Packet Guide
City of Charlottesville
Board of Architectural Review
Regular Meeting
September 17, 2024, 5:30 p.m.
Hybrid Meeting (In-person at CitySpace and virtual via Zoom)

**City of Charlottesville
Board of Architectural Review
Staff Report
September 17, 2024**

BAR # 24-09-02

Certificate of Appropriateness

Elevations mounting finishes

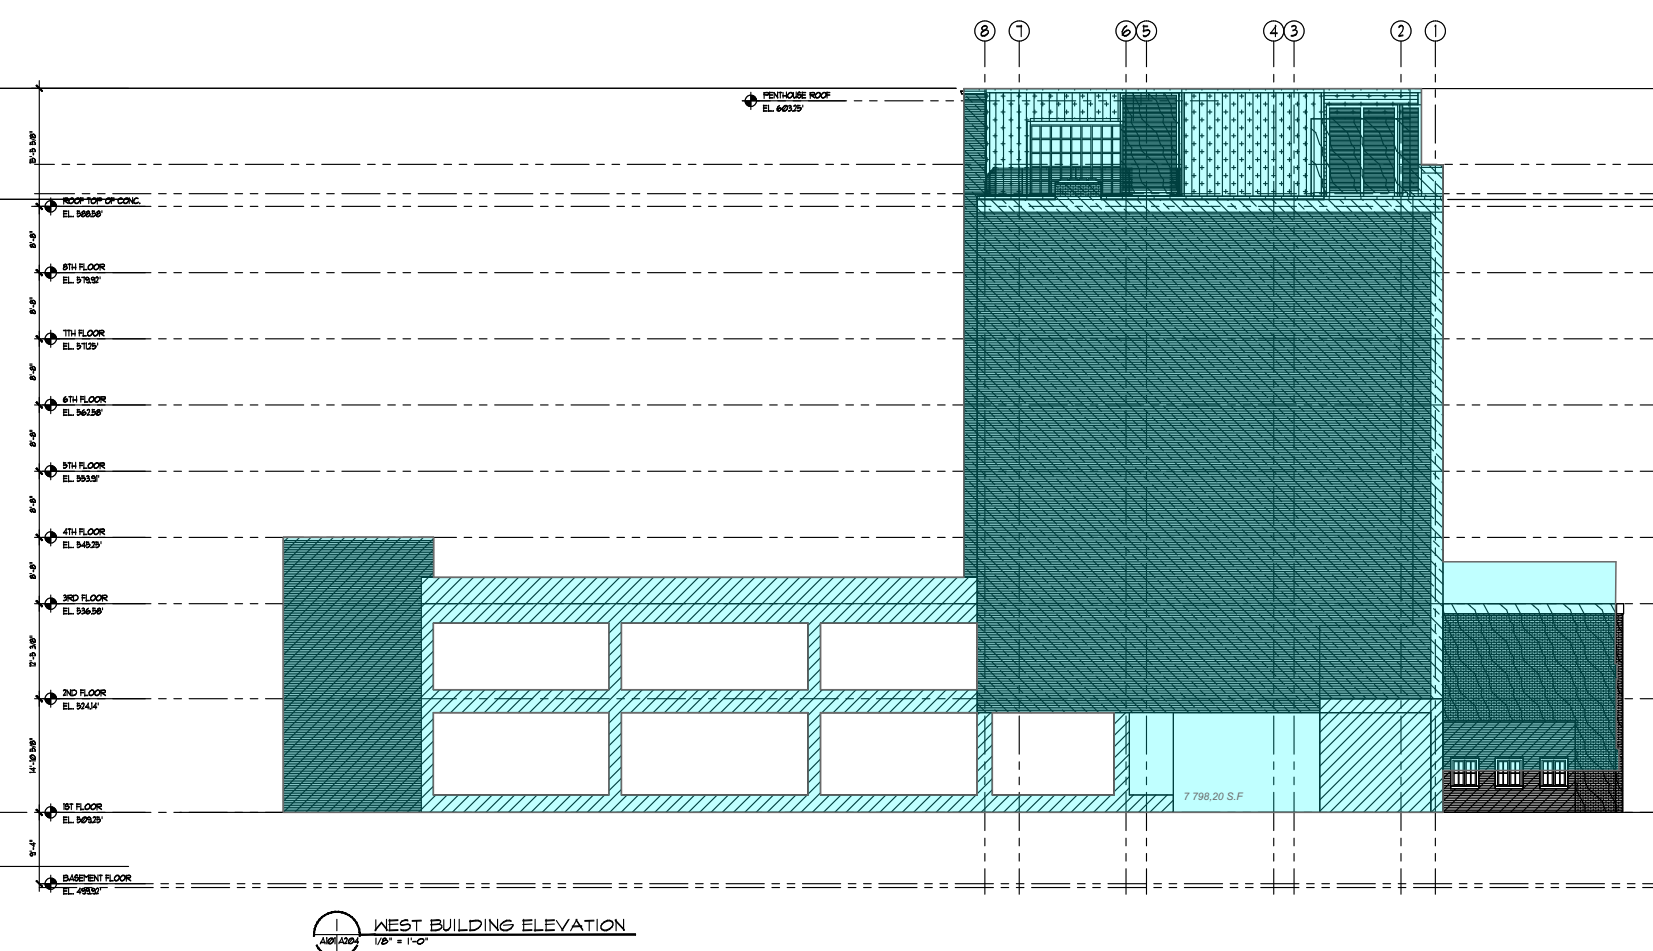
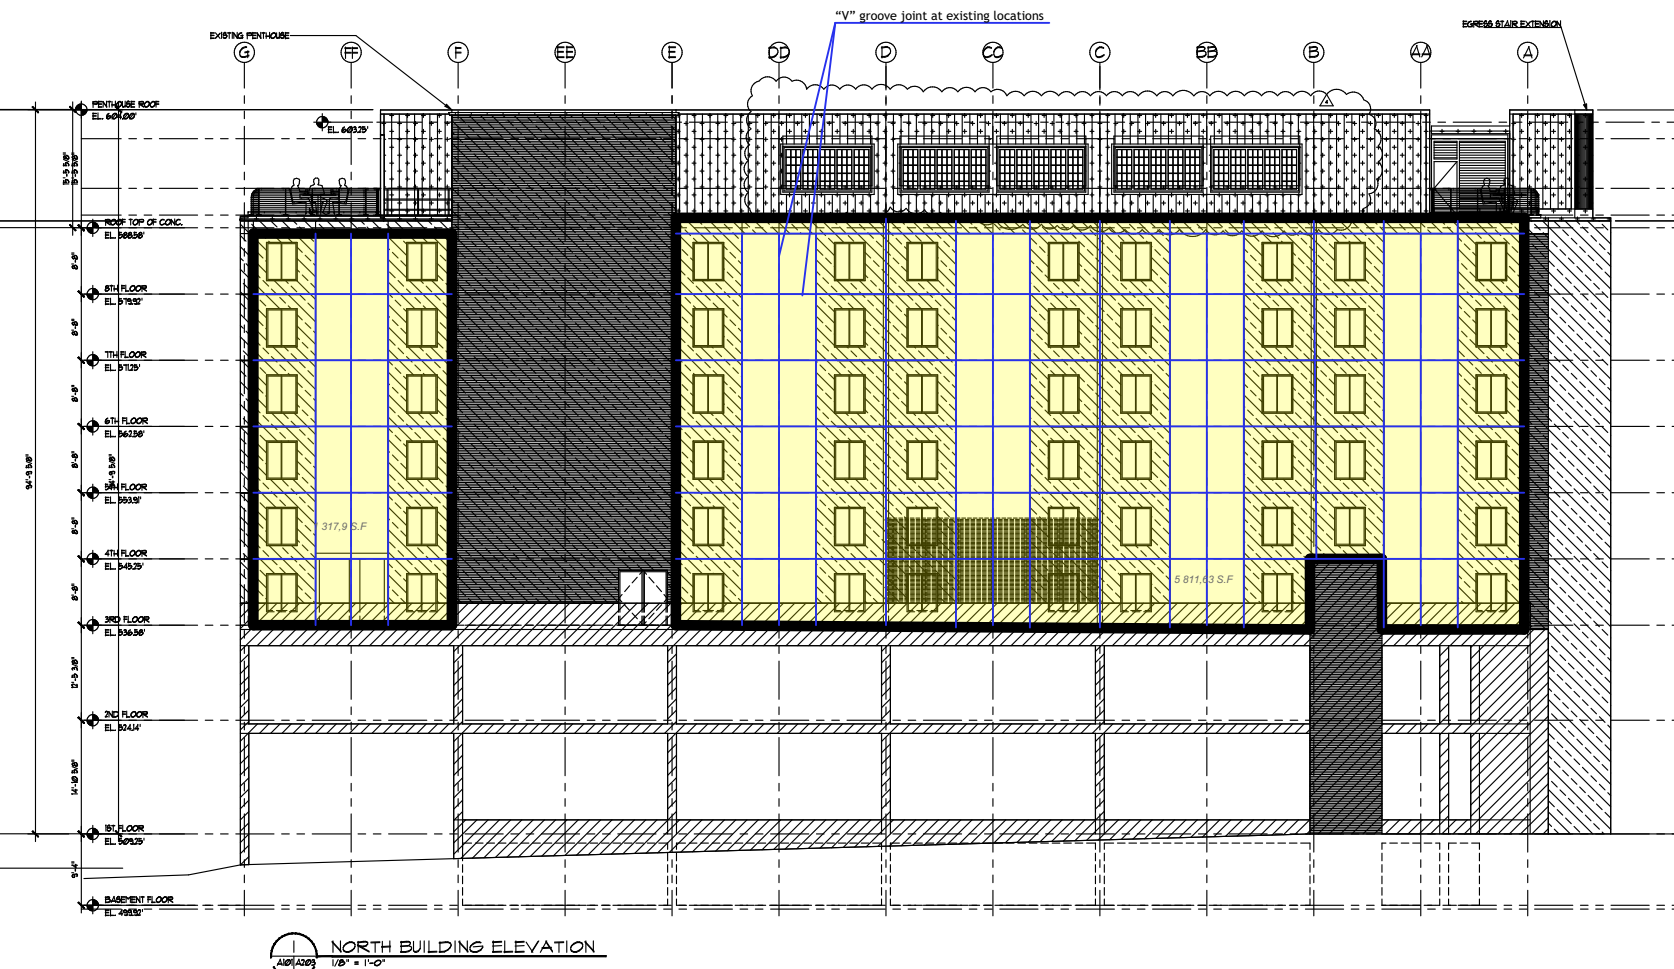
The EIFS will replace non-original, skimmed wall panels (installed mid-1990s) and the work will improve the insulation of the exterior walls. The specified material is drainable, with an air and moisture barrier.

The expansion joints are consistently located and symmetrical with the building's bays and floor levels.

The proposed color palette (grays and earth tones) is appropriate.

Staff recommends approval of the requested CoA with the condition noted below.

Per administrative CoA, July 8, 2024

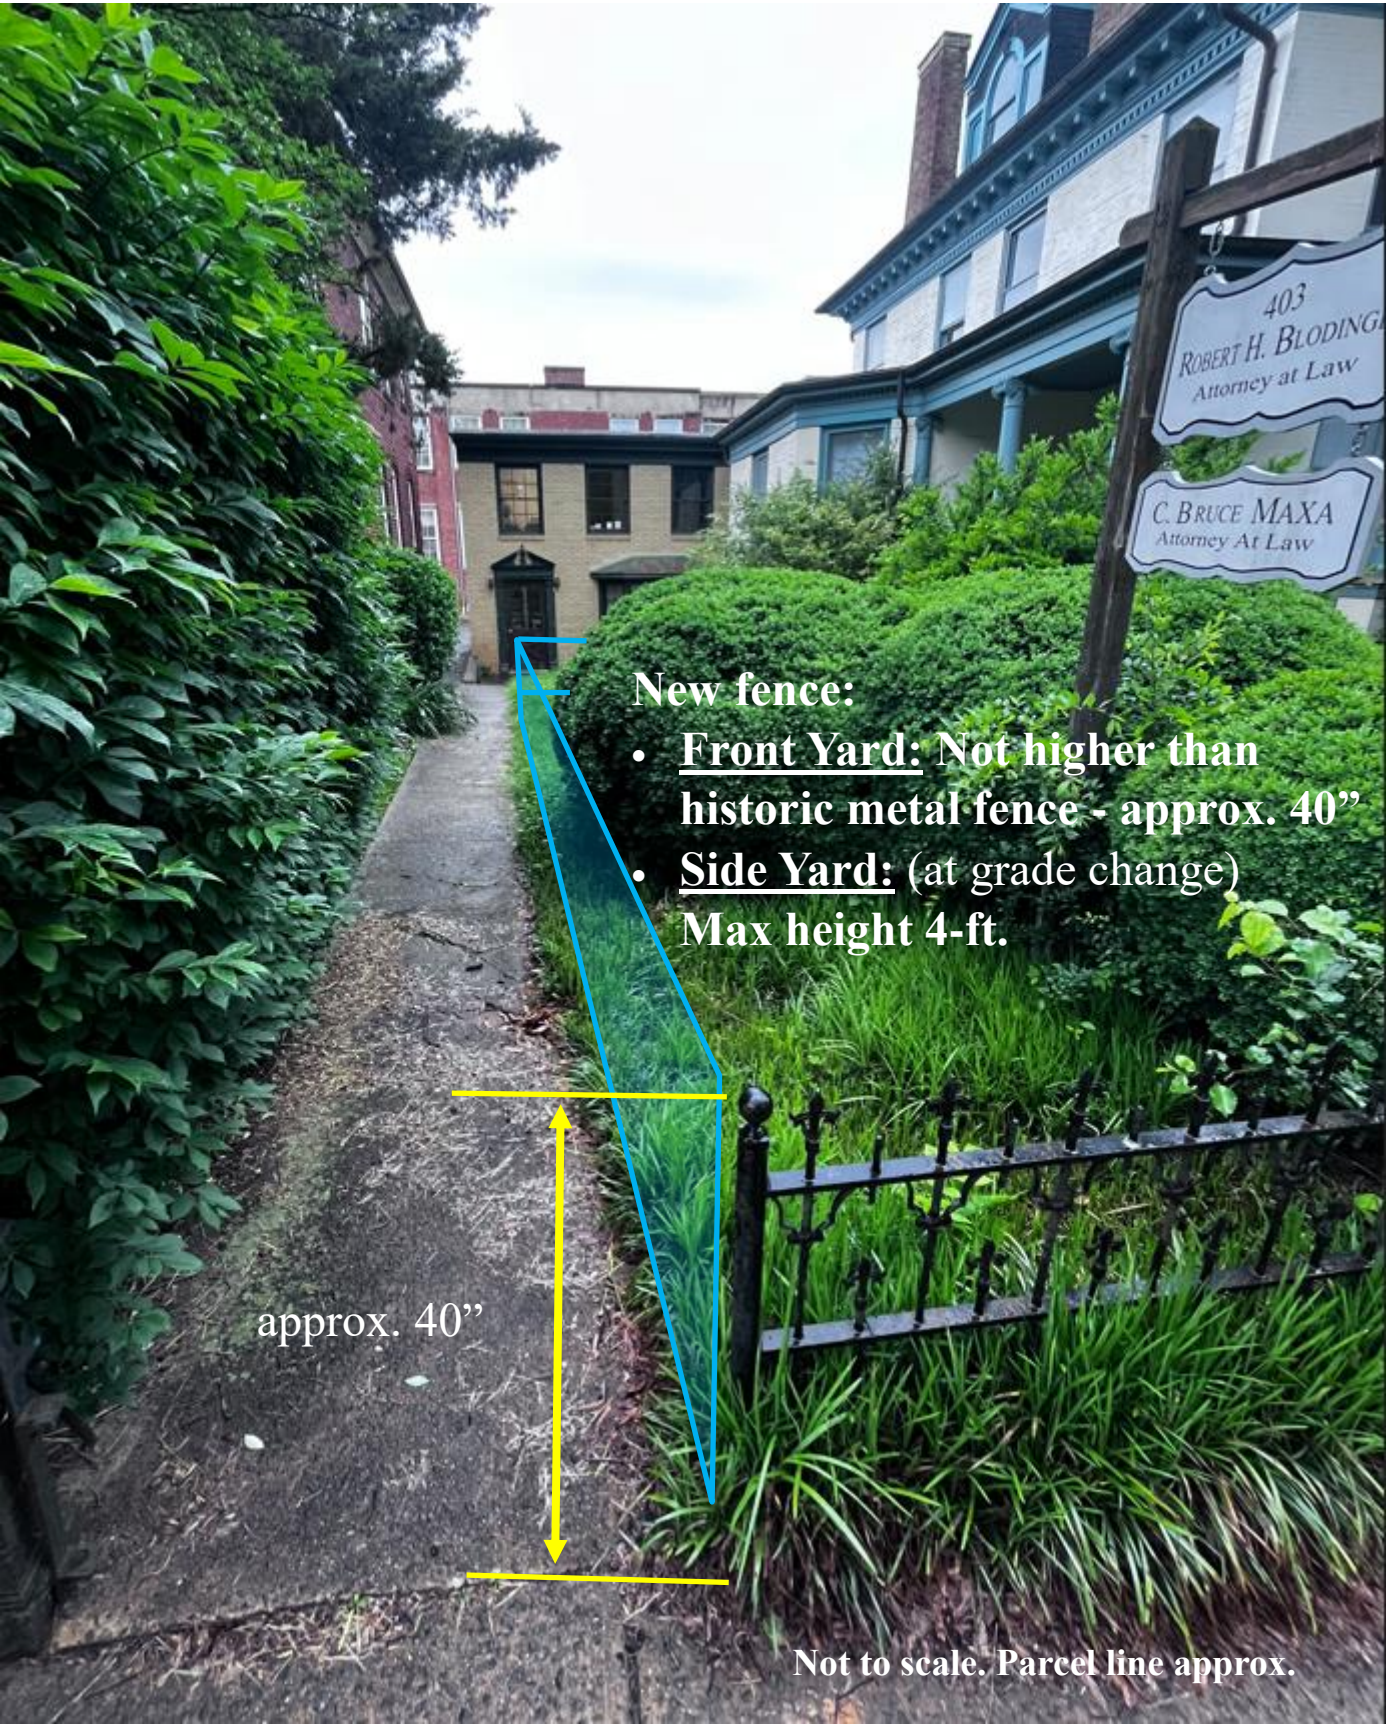
During construction and following completion of this section, staff informed the applicant the fence at the SE corner must not be taller than the historic fence. Following completion, the applicant stated the fence complied with the CoA because while the new segment was taller where it met the historic fence, the height was no taller than other, non-adjacent sections of the historic fence. Staff was unwilling to allow the change; however, the applicant was invited to submit an application requesting the BAR allow it.

From staff email to the applicant, August 19, 2024: "... I noticed the posts and rails along the south boundary had been constructed taller than the historic metal fence."

From staff to the applicant, August 27, 2024: “Your contractor installed the fence too high on the south side, so it will have to be reworked.”

- Front yard: not higher than historic metal fence.
- Side yard: max height 4-ft.
